V2500-A5 SERIES PROPULSION SYSTEM NON-MODIFICATION SERVICE BULLETIN

This document transmits the Revision 1 of Non-Modification Service Bulletin V2500-ENG-71-0315.

V2500-ENG-71-0315

NON-MODIFICATION SERVICE BULLETIN – POWERPLANT – EBU – HYDRAULIC SUCTION LINE AND
FUEL RETURN LINE HOSES – INSPECTION FOR APPLICATION OF PROPER TORQUE

Inspection for proper torque of Hydraulic Suction Lines installation
Figure 1

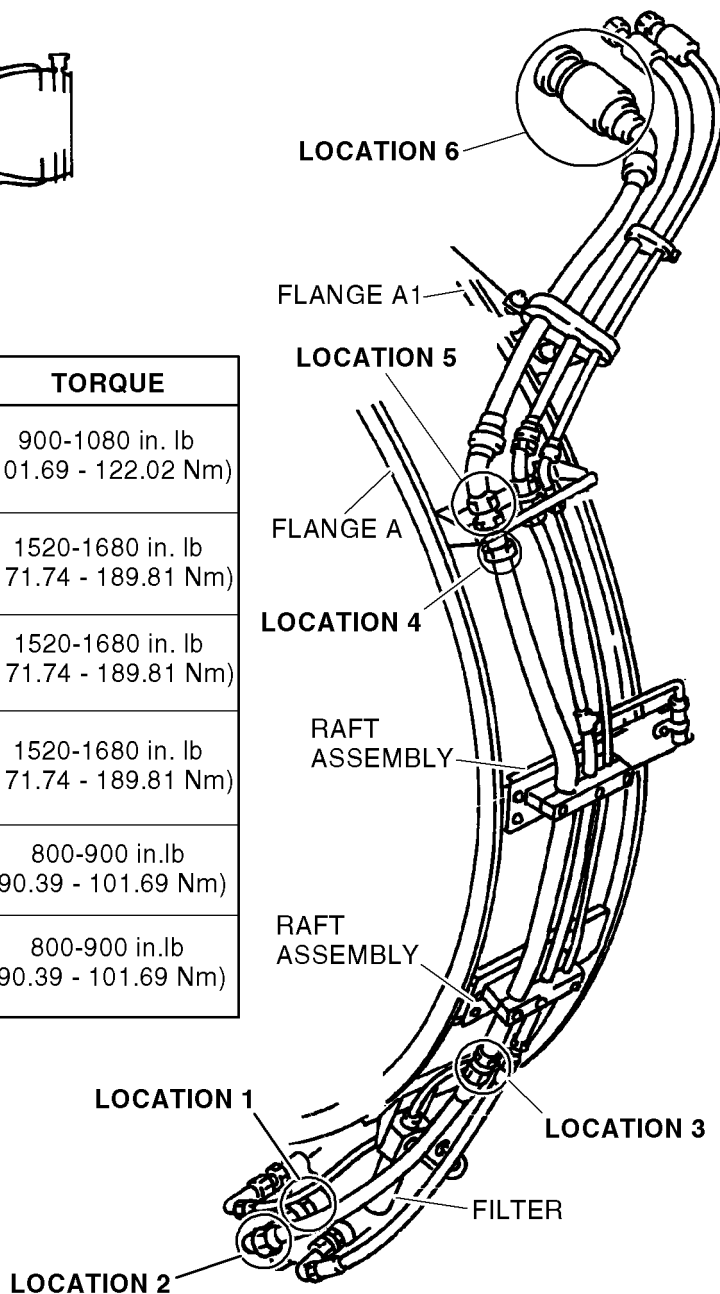
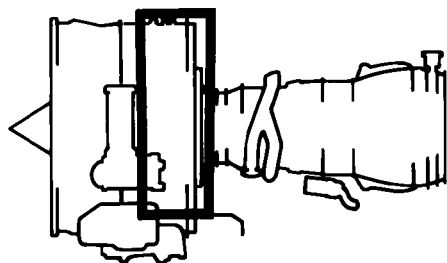
- (1) Using an appropriate torque wrench, verify the installation torque on the subject Hydraulic Suction Line connections, see Figure 1. Refer to the Airbus Aircraft Maintenance Manual, Chapter/Sections 29-11-49, Task 29-11-49-400-010, Subtask 29-11-49-420-050 for Engine No 1.
- (2) Using an appropriate torque wrench, verify the installation torque on the subject Hydraulic Suction Line connections, see Figure 1. Refer to the Airbus Aircraft Maintenance Manual, Chapter/Sections 29-13-49, Task 29-13-49-400-010, Subtask 29-13-49-420-050 for Engine No 2.
- (3) Using an appropriate torque wrench, verify the installation torque on the subject Fuel Line connections, see Figure 2. Refer to the Airbus Aircraft Maintenance Manual, Chapter/Sections 73-11-48, Task 73-11-48-400-010, Subtask 73-11-48-420-052.

LOCATION	CONNECTIONS	TORQUE
6	AE81266P (COUPLING) TO AE707874-3 (HOSE)	900-1080 in. lb (101.69 - 122.02 Nm)
5	AE707874-3 (HOSE) TO MS21924-20 (UNION)	1520-1680 in. lb (171.74 - 189.81 Nm)
4	MS21924-20 (UNION) TO 740-5600 (TUBE)	1520-1680 in. lb (171.74 - 189.81 Nm)
3	740-5600 (TUBE) TO AE707874-2 (HOSE)	1520-1680 in. lb (171.74 - 189.81 Nm)
2	AE707874-2 (HOSE) TO AE96787N (COUPLING)	800-900 in.lb (90.39 - 101.69 Nm)
1	AE96787N (COUPLING) TO MS21924-20 (UNION)	800-900 in.lb (90.39 - 101.69 Nm)
